RECALL 26V336 / 2026-255 REMEDY INSTRUCTIONS

TOURING COIL SUSPENSION SHOCK BOLT REPLACEMENT

Recall Number	26E-032		
Product:	Curt Touring Coil Suspension		
Date:	05/27/2026	Labor Rate:	Tandem Axle - 0.8 hrs Triple Axle - 0.9 hrs

Lippert has identified instances where CURT® Touring Coil Suspension (TCS) shock bolts may have been improperly torqued during installation. Although we are confident it is a small quantity, out of an abundance of caution, Lippert is issuing this Safety Recall to replace all shock bolts on units equipped with factory-installed TCS on Lippert chassis manufactured prior to April 23, 2026.

Fig. 1

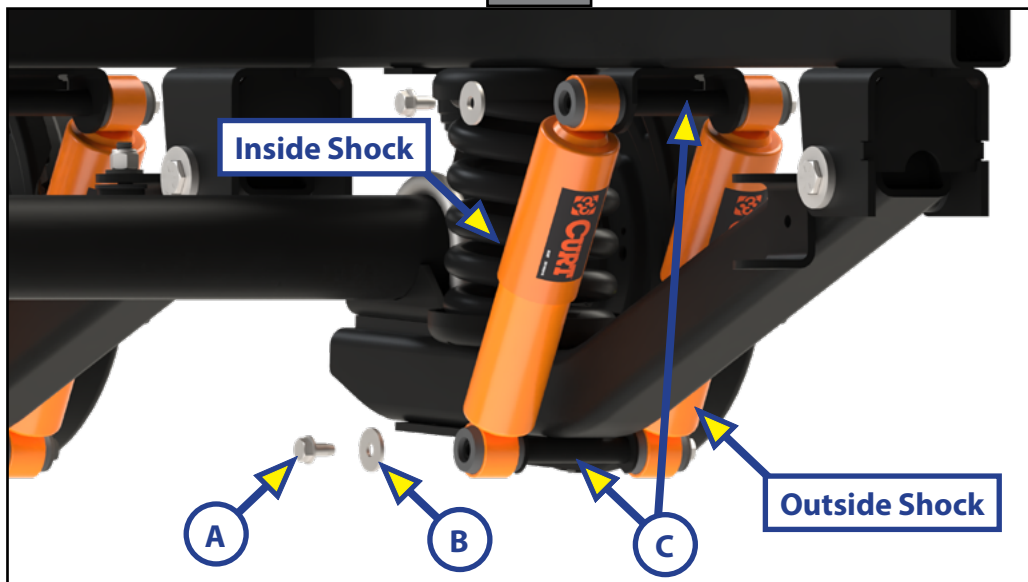
1. Starting with the inside shocks, loosen and remove the two existing $\frac{3}{8}$ "-16 x $\frac{3}{4}$ " thread forming screws (Fig. 1A) and washers (Fig. 1B) securing each shock absorber onto its posts (Fig. 1C). Retain washers (PN 249853) for reinstallation in Step 2.

2. Reinstall previously-removed washers onto two new $\frac{3}{8}$ " - 16 x $\frac{3}{4}$ " Grade 8 hex head bolts.

This document outlines the procedure for replacing existing $\frac{3}{8}$ "-16 x $\frac{3}{4}$ " thread forming screw with $\frac{3}{8}$ "-16 x $\frac{3}{4}$ " Grade 8 hex head screws at all Touring Coil Suspension shock absorber locations on a unit. This procedure uses Bolt Replacement Kit PN 2026070484.

Fig. 4

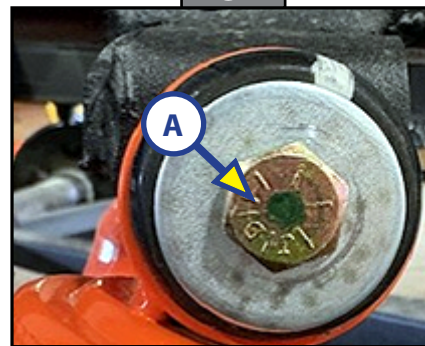
7. Once all bolts have been tightened to 20-30 ft-lbs spec, apply a green or yellow dot of epoxy paint (Fig. 3A) onto the newly-installed bolt to indicate completed repair status.

3. Apply two threads of Loctite® Blue 242® (or locally sourced equivalent) to the Grade 8 bolt threads (Fig. 2).
4. Install new bolt assemblies by hand for a minimum of three full threads (or three turns) before proceeding to Step 5.
5. Torque new Grade 8 bolts to 20-30 ft-lbs. Do not over-torque bolts.
6. Repeat procedure on all other inside and outside shock absorber bolts.
